**RE: Technical Comments on La Jara Mesa Mine, Permit No. CI008RN**

Subject: **New Mexico Environment Department (NMED) Comments, La Jara Mesa Project, Cibola County, New Mexico, Mining Act Permit No. CI008RN**

RE: HPD Log #123506— Request for Review and Comment on the Draft Baseline Data Report; La Jara Mesa Mine, Laramide Resources (USA) Inc., Permit No. CI008RN

**SUBJECT:** La Jara Mesa Mine Project, Cibola County, New Mexico, CI008RN

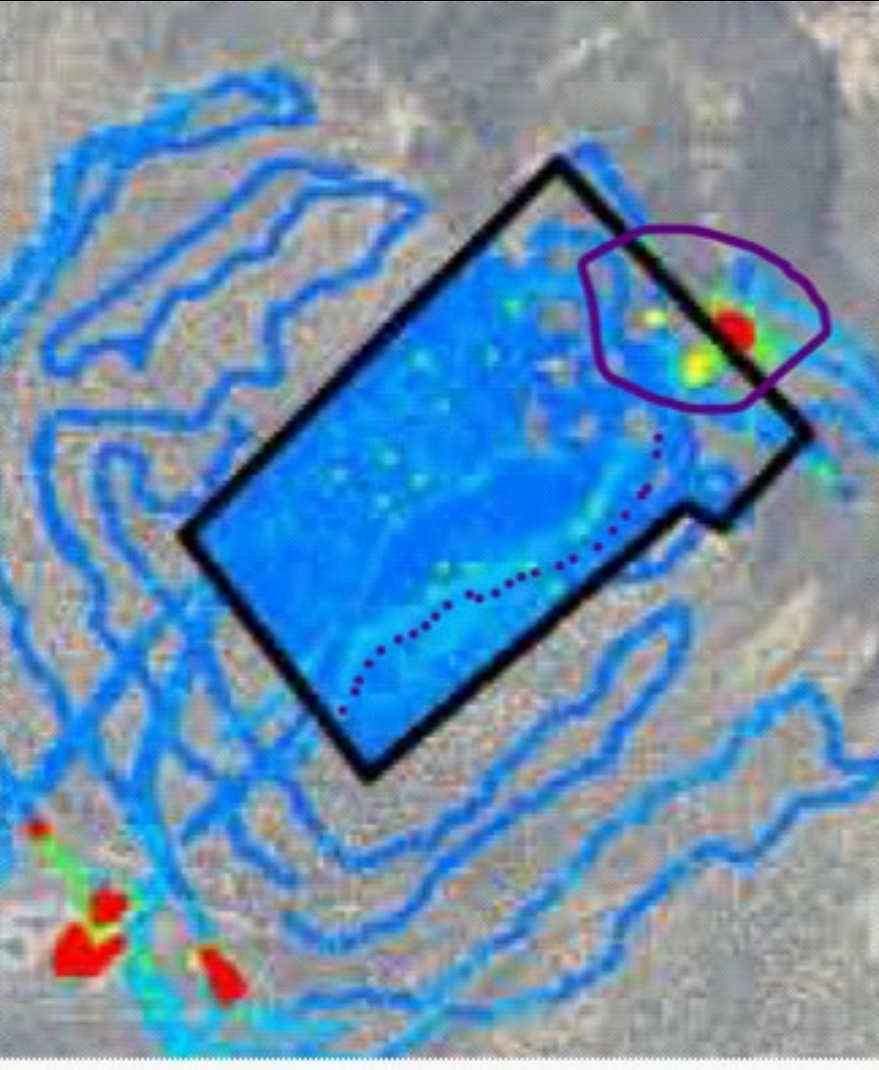
6	General		<p>Site access and Permit area: With the road re-route and change in supply well, will the section of road marked in blue still need be needed and upgraded?</p>

7	General	Figure 2, section 9.2.2	<p>It is MMD's understanding that the proposed supply well (Elkins well B-01272) marked at this location is no longer relevant due to low production. Please provide an updated Well location and data associated with anticipated well quality and production. Additional data (i.e., modeling or pump testing) will be required to demonstrate the probable hydrologic consequences of well utilized for mine operations.</p>
8	General	Figure 10 & Multiple maps	<p>between the SAP and the Draft BDR, many of the maps show two different boundaries of the permit area/design limit. The SAP mainly defines the Permit Area as a larger rectangle shape, versus the Draft BDR mostly depicts the area as a more narrowed "tear drop". The tear drop shape would be what MMD calls the design limit. MMD requests for clarity and consistency to keep both boundaries marked on the maps. Plate 2, "Conceptual Mine Layout Plan" from the Draft BDR is a good example of including both the Permit Area as well as the design limit.</p> <p>The Permit Area should be carefully considered by Laramide. For example, inclusion of a large drainage (Drainage B later in this document) parallel to the northwest edge of the Permit Area as drawn may require additional baseline data to be collected if this drainage will in fact be utilized in some way during mine operations or reclamation. This is not clear in the BDR; the "tear drop" disturbance does not appear to incorporate this drainage into any disturbance or design, yet it appears to be included in the Permit Area. Please consider and refine the Permit Area as needed for the agency's consideration for baseline data collection.</p>
